Correspondence.

Fig. 1.

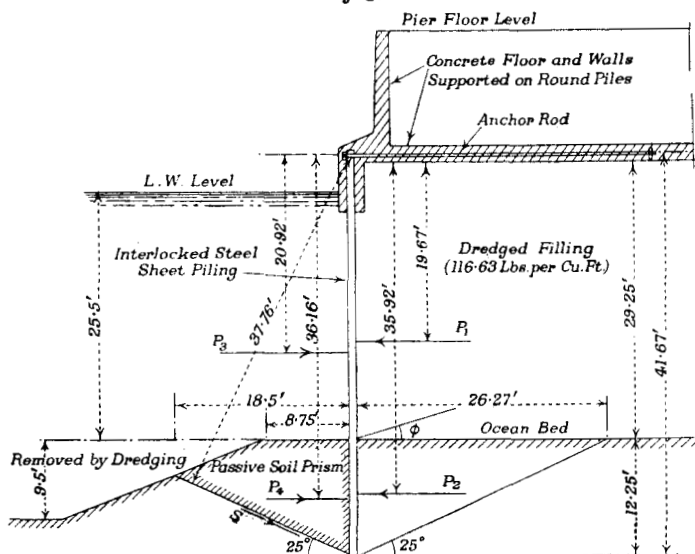
resultant force produced a factor of safety of stability which did not exist for moments calculated about the anchorage at low-water level. Any soil wedge against either face of the sheet-pile wall could have but one resultant force value, and it certainly seemed an erroneous deduction to change a sign in the expression for that force before arriving at its value, merely because there were forces acting on the opposite side of the wall. Text-books treated of the deduction of the active factor, leaving the student to figure the passive resistance from a complexity of unit and conjugate stresses, or ellipses of stress. He recommended the same formula, using the value $(1 - \sin \phi)/(1 + \sin \phi)$ for the passive force as well as for the active force, thus arriving at all horizontal soil forces by the same formula—which would readily be acknowledged as logical—then solving

separately the resistance force along the angle of repose, which force Mr. Rothery. was simply the product of the combined consolidated weight of the passive soil unit, due to its own weight and the surcharged weight of water, and the sine of the angle of repose. That force was the shearing resistance along the angle of repose (strictly speaking, the complement of the angle of rupture should be used, which was somewhat larger than the angle of repose). The moment of the resisting force about the same anchorage acted in conjunction with the passive forces, determining whether the structure had a factor of safety or was unstable. The soil along the shearing plane had a definite cohesive or shearing resistance per cubic foot, which must be known and not exceeded when the resisting force was divided by the length of the plane. With regard to the Long Beach failure to which he had referred, *Fig. 1* showed the dimensions and positions of the forces acting on a sheet-piling wall 41·67 feet deep ; at one of the critical points, P_1 , P_2 , P_3 , and P_4 had been computed by the Rankine formula, and S had been computed as already stated. The weight of the interlocked sheet piling was 31·75 lbs. per square foot. The filling-material was sandy mud dredged from the ocean floor, its mechanical analysis being—

Mr. Rothery. when P_4 was the passive resistance found by the inverted factor $(1 + \sin \phi)/(1 - \sin \phi)$, the following values were obtained:—
 $P_1 = 49,892$ lbs. when $\phi = 0^\circ$ and $25,919$ lbs. when $\phi = 18^\circ 26'$;
 $P_2 = 20,521$ lbs., $P_3 = 20,808$ lbs., $P_4 = 64,451$ lbs. Their moments gave an exaggerated factor of safety of 1.6 to 2.2 for values of ϕ from 0° to $18^\circ 26'$ of the filling, and the shearing force against the toe prism was unknown. Applying the similarly-calculated horizontal forces against the piling, P_4 appearing as a similar soil force to P_1, P_2, P_3 , and calculating the resistance force, S , acting along the angle of repose, $P_1 = 49,892$ lbs. and $25,919$ lbs., $P_2 = 20,521$ lbs., $P_3 = 20,808$ lbs., $P_4 = 10,615$ lbs., $S = 19,154$ lbs. The moments of those forces showed failure when $\phi = 0^\circ$, giving a factor of safety of only 1.2 when $\phi = 18^\circ 26'$, and as the length of the plane of rupture was 19.5 feet, the soil had to resist a shearing stress of $19,154/19.5$ or 980 lbs. per square foot, which was excessive for soil and might have accounted for the failure. Sudden outbursts occurred in several places, bending the steel sheet piling wall outward and releasing the soil behind the wall. The distortion of the piling was evidence of excessive active moments, or lack of soil cohesion, for the length of piling used.

between active and passive stresses, whilst disregarding his methods of computing those stresses. Then, if the vertical stresses in front of the wall were represented by W_1 , the passive conjugate stresses in front could be visualized as rising, during loading, from just over kw to W_1/k . He did not wish to suggest that a pressure uniformly increasing from dock-bed level to bottom of wall and calculated on the latter formula would be a safe assumption to make : there were many more factors to be considered. He had no general proposition to propound, but quay-walls were a special case. There was about quay-walls, built for ocean-going ships, a degree of uniformity which made it possible to consider such walls as in a class by themselves. The calculations made for the King George's Dock quay-walls contained the inherent assumption, not perhaps realized at the time, that the earth-pressure on the face of the wall just below dock-bed level was only 37 per cent. of the water-pressure just above, and further, that the increase of intensity per foot of depth below that was less than that which would be due to water. Had the dock been dredged out to the level of the toe of the wall, the wall would have appeared, so far as the figures went, to be very much more stable. He had analysed the conditions applying to certain existing walls and had found that they could not possibly be stable if such were the nature of the stresses. He had concluded that the earth-pressure just below bed-level must be at least equal to that of the water just above, though it need not necessarily exceed it. The distribution of stresses below that level was admittedly indeterminate at present, but the method of treatment for "flexible" walls which he had worked out for himself, though too lengthy to describe in this connection, was based on the belief that the passive conjugate earth-pressure

- (a) might at bed-level be taken as equal to that of the water above ;
- (b) would increase to a maximum not exceeding W_1/k at a point between bed-level and the bottom of the piles ; and
- (c) would diminish below that point, though not necessarily to zero, at the bottom of the piles.

As an instance, this would indicate, in a case where $k = 0.5$, a pressure equal to twice the vertical pressure, acting on the face of the piles, but purely locally. The question of the *vraisemblance* of such a method could be decided by working out various cases ; it was not susceptible of direct proof. He would not venture to apply such reasoning to the Long Beach wall, of which Mr. Rothery gave particulars, on account of the deepening in front of the berth, which would seem to render the distribution of stresses more problematical than ever. The section seemed to be a very hazardous one

to adopt, though it was noted that Mr. Rothery attributed failure to under-estimation of active, not passive, forces. It would have been interesting to know whether there had been movement at bed-level. No account had apparently been taken, in the computations, of the support afforded by the anchor-rod. It would be regrettable if failures such as that set back the clock. Mr. Rothery's method of computing toe resistances seemed preferable to that of assuming a mere active pressure, but Mr. Ash was at a loss to see its justification. It appeared to take into account the same force twice over. The value $(1 - \sin \phi)/(1 + \sin \phi)$ was of itself nothing but an expression for the horizontal reaction due to a prism of earth; but under this method of computation there was added to it the reaction from another and a bigger prism, comprised in the same mass. Mr. Ash found difficulty in accepting that. In reply to Mr. Milne's further queries, the calculations of the King George's Dock quay-walls had been based on an assumption of an angle of repose of $80^{\circ} 36'$ and the 36-foot wall had been found to be liable to overturn. Mr. Ash believed that a specific angle of repose, when applied to such soil, was almost meaningless. It would stand at all sorts of angles, according to the conditions, and when there was a slip it was generally along a surface which was approximately parabolic. The toe pressure of the 44-foot wall had under the method adopted been calculated at 5.3 tons per square foot.
